Regulations Nos. 37 (Filament lamps), 99 (Gas discharge light sources) and 128 (Light emitting diodes light sources)**Proposal for Supplement 5 to the original version of
Regulation No. 128 (Light emitting diodes light sources)****Submitted by the expert from the International Automotive Lighting
and Light Signalling Expert Group***

The text reproduced below was prepared by the expert from the International Automotive Lighting and Light Signalling Expert Group (GTB) to introduce new Light Emitting Diodes (LED) light source categories LW3, LY3, LR5, LW5 and LY5, and to align some drawings of category LR4 with drawings of these new categories. The modifications to the existing text of the Regulation are marked in bold for new or strikethrough for deleted characters.

Figure 1*

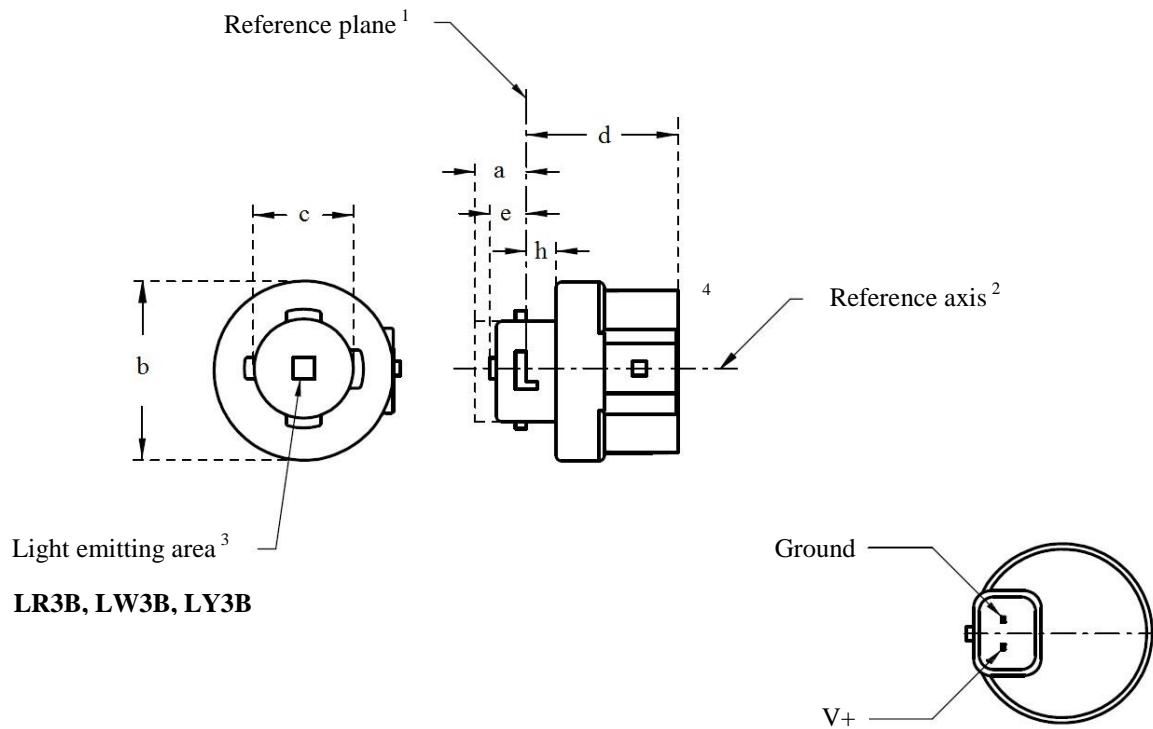
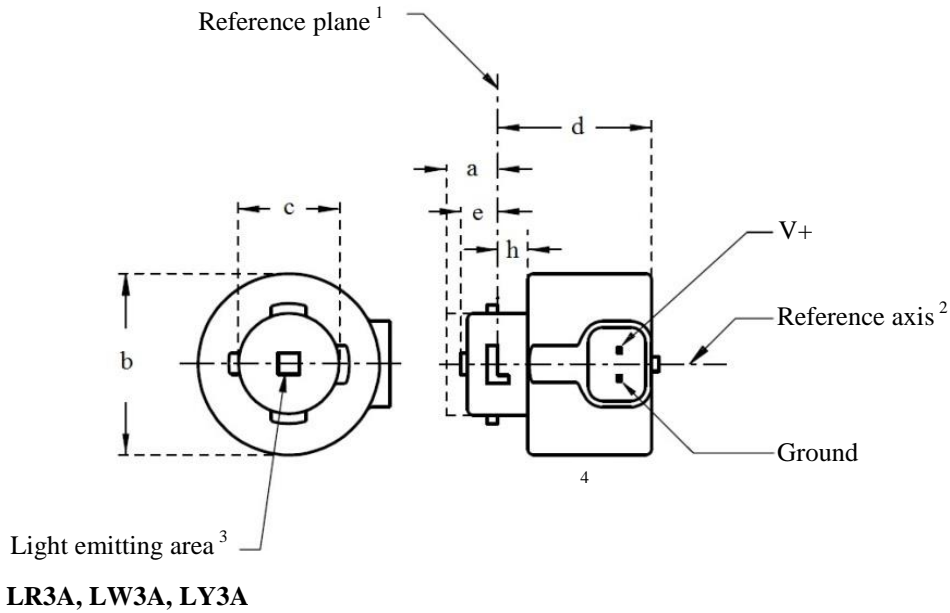
Sheets LR3/1 to 5, replace by new sheets L3/1 to 6, to read (see following pages; one page per sheet):

2. Light source categories emitting white and amber light, both with an elbow connector at the side – the A version – and with a straight connector at the bottom – the B version – are proposed to complete the red light emitting categories LR3A and LR3B.

4. The cap/holder system for LR3A and LR3B allows many other keys. For the newly proposed LED light source categories no new system needs to be developed and keys not in use so far have been assigned to the newly proposed categories.

Figure 1*

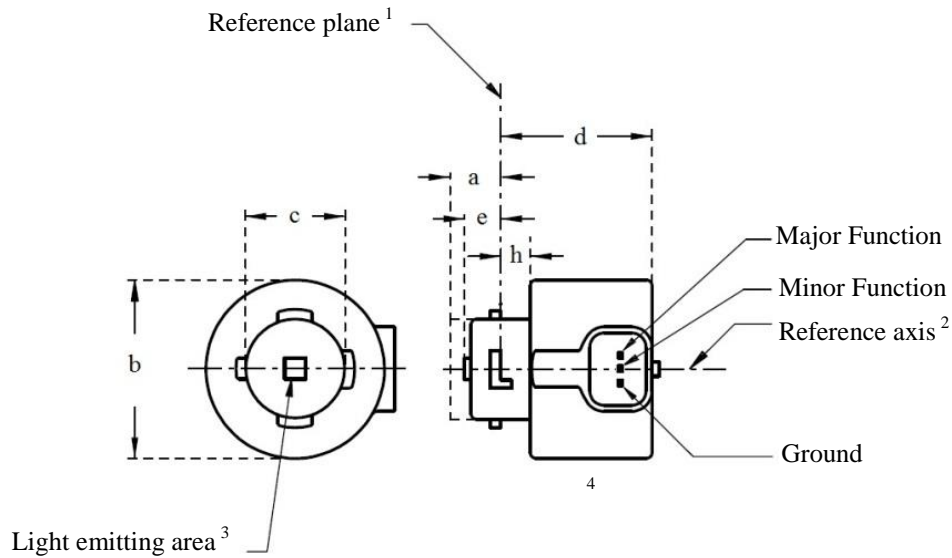
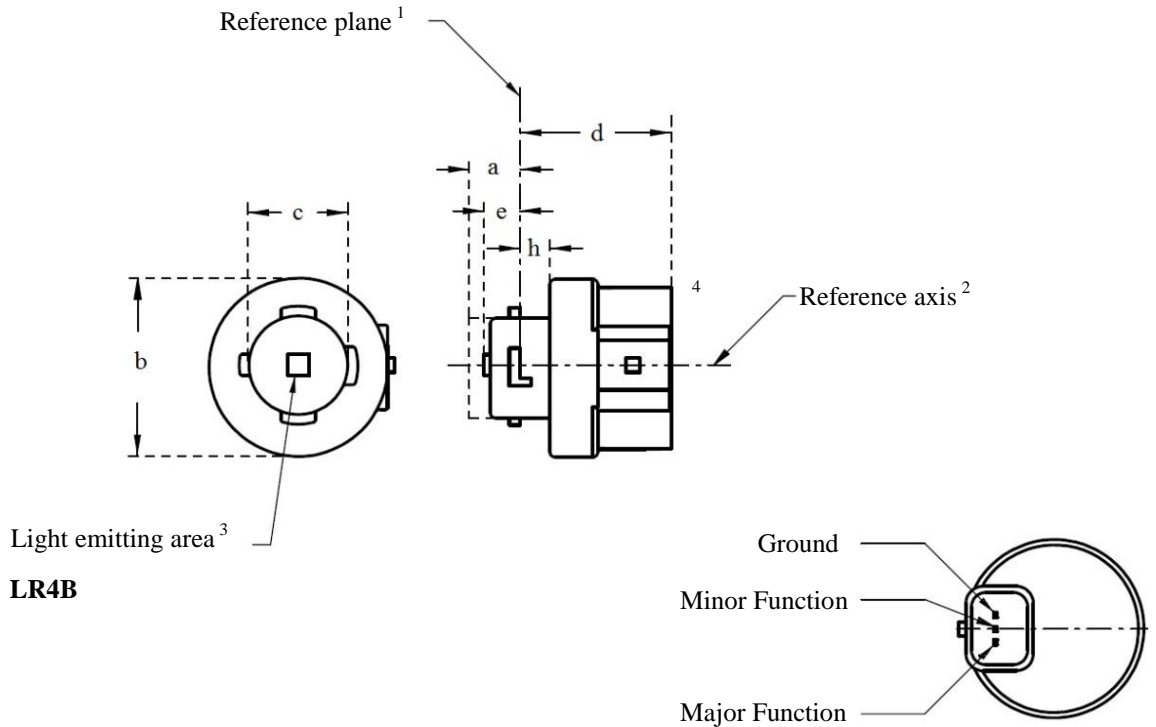
Sheet LR4/1, replace by new sheet LR4/1, to read (see following pages):

5. For consistency, the sheets LR4/1 and LR4/4 were replaced by new sheets to align the main figures with the main figures of L3 and L5, which in turn were aligned with the drawings in standard IEC60061.

Figure 3*
Set-up to measure the luminous intensity distribution

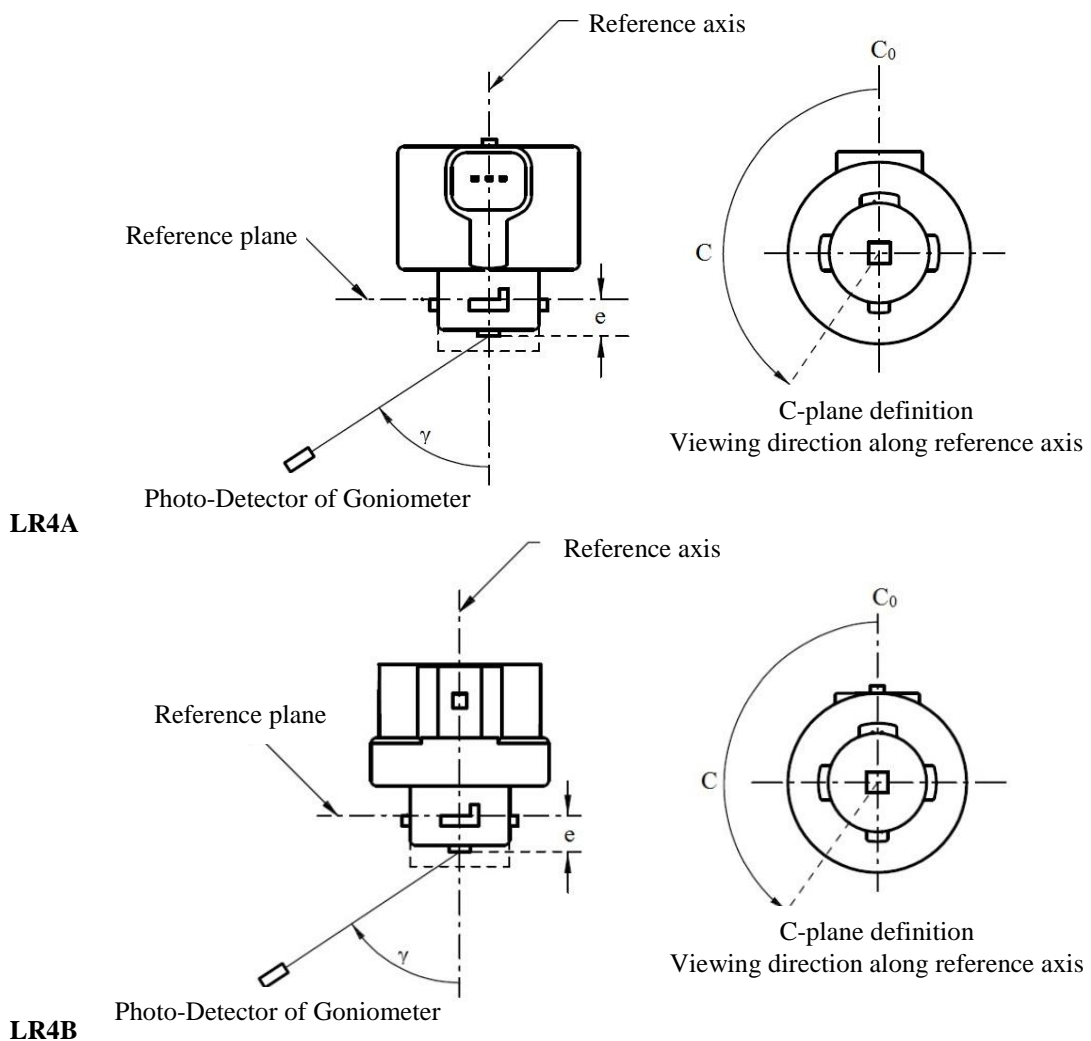
Sheet LR4/4, replace by new sheet LR4/4, to read (see following pages):

Figure 1*
Main Drawing

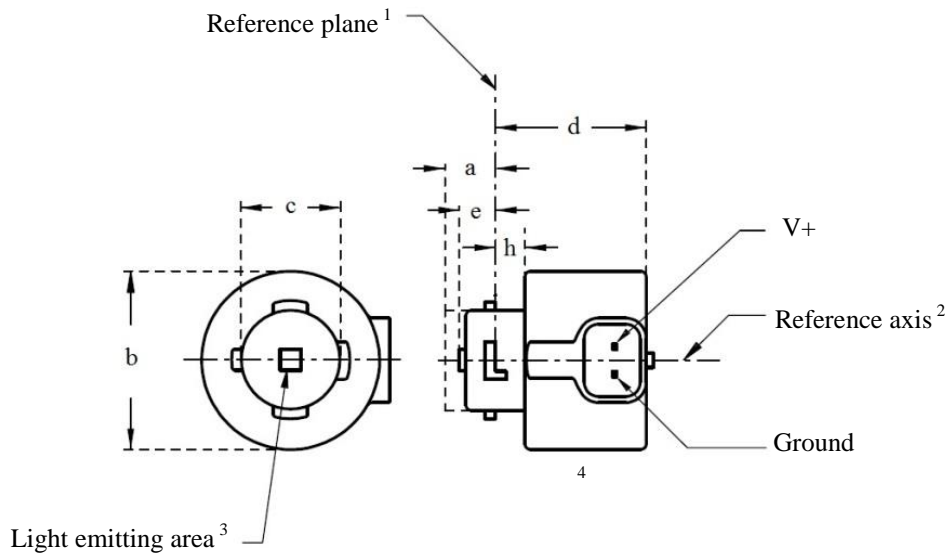
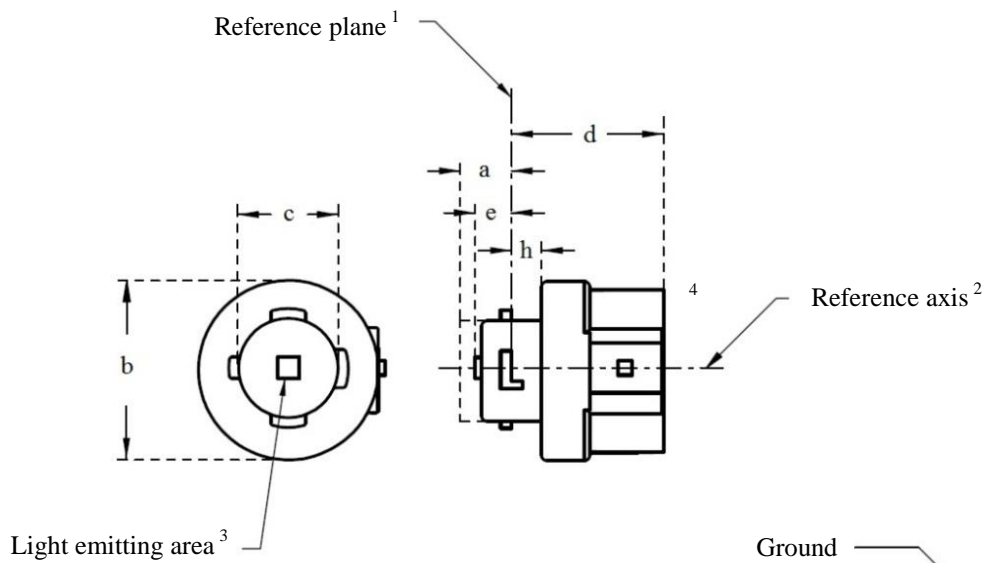
After sheet LR4/5, insert new sheets L5/1 to 6, to read (see following pages; one page per sheet):

3. The L5 light source categories are more or less identical to the L3 categories. The main difference is a higher luminous flux and consequently mostly a higher power consumption. The L5 categories are intended for use in lamps for which higher luminous intensity values are required.
